RE: Update to SSDR GA-1115-D-101-S

Novoste™ Corporation is requesting an update to SSDR certificate GA-1115-D-101-S to add a new design of the investigational Corona™ Delivery Catheter that is compatible with the *Model A1767 Transfer Device and AEAT SICW.2 sources.*

Corona™ System Delivery Catheter Description

Image of Corona™ Delivery Catheter For Use with the A1767 Transfer Device

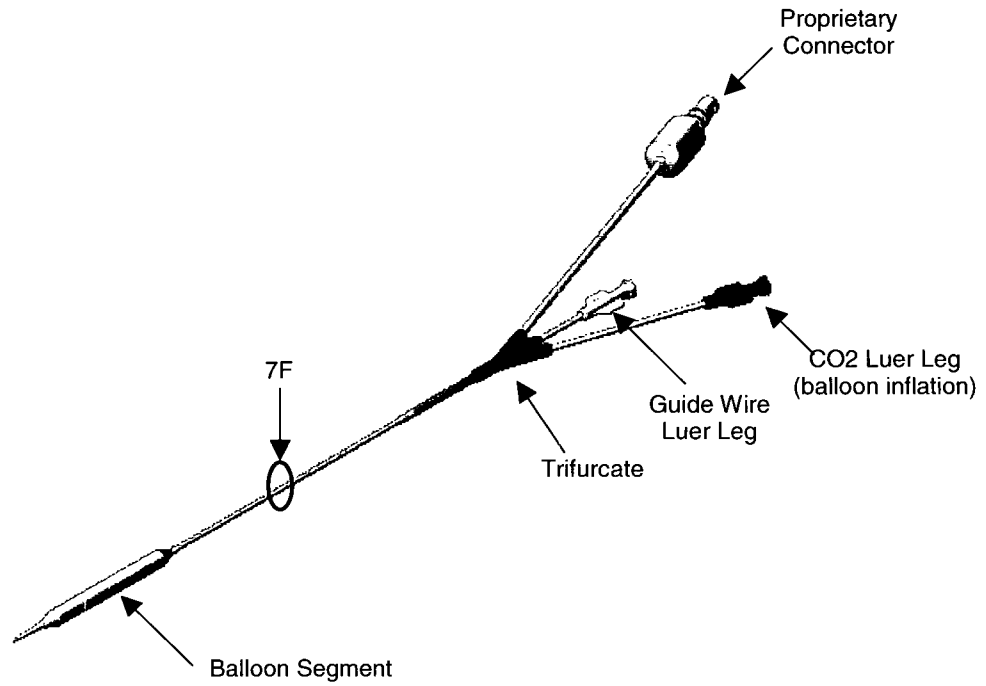
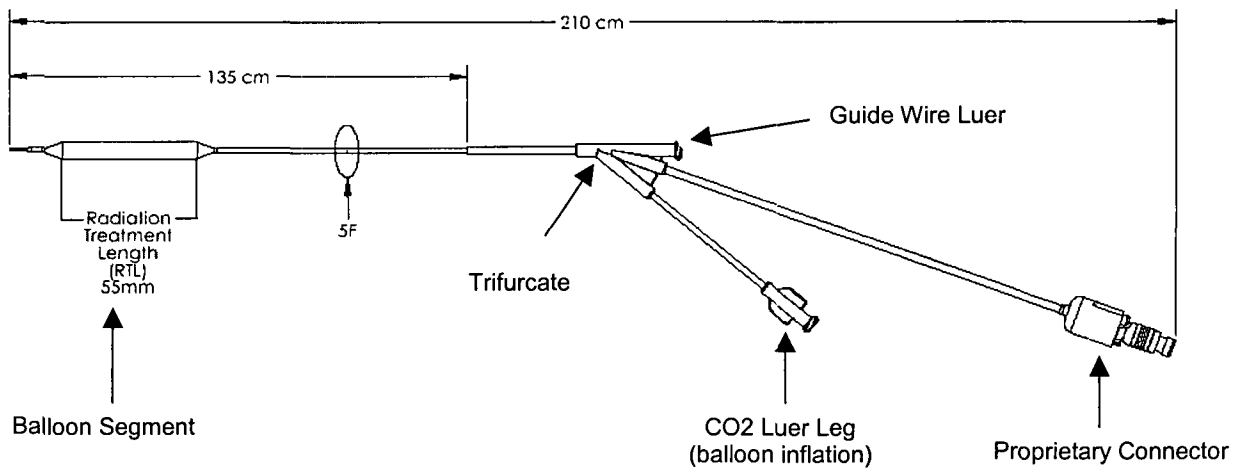
The already registered Corona™ System Delivery Catheter for use with the A1730 Transfer Device has a 7F profile (7/3 mm diameter) to accommodate the large diameter Radiation Source Train used in that device.

The new Corona™ System Delivery Catheter for use with the A1767 Transfer Device has a smaller 5F profile achievable with the small diameter Jacketed Radiation Source Train.

The overall length, outer diameter, source train lumen diameter and relative position of the Proprietary Connector leg, Guide Wire leg and CO₂ leg vary between the Corona™ Delivery Catheter designs, but the main shaft material (PEBAX), and four-lumen design are the same. Two images are provided on the following pages for comparison.
